City of White Rock

**REQUEST FOR QUOTATION – WR19-049
Memorial Park Handrail Replacement**

Addendum No. 1 - Issued December 4, 2019

QUESTIONS AND ANSWERS No. 1

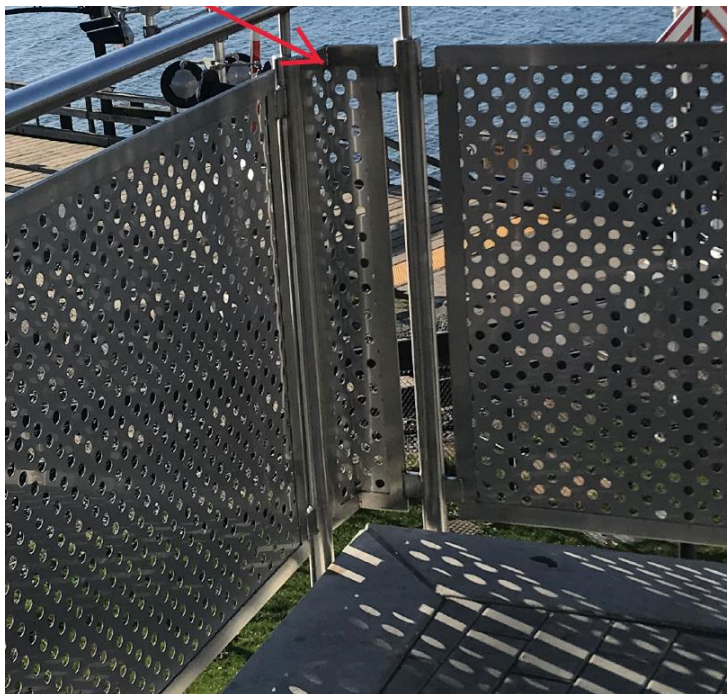
Q1: What is to be done for new handrail at inside corner locations? (see photo below)

A1: Our expectation was to have the existing remain, as the cabling will not work in these corners, but the City should confirm they are satisfied with this scenario. There are 4 instances of inside corners and 3 of outside corners. Alternately, the contractor can provide shop drawings to match the design intent for an inside and outside corner transition. This will likely result in a 45 degree angle connecting the two posts.
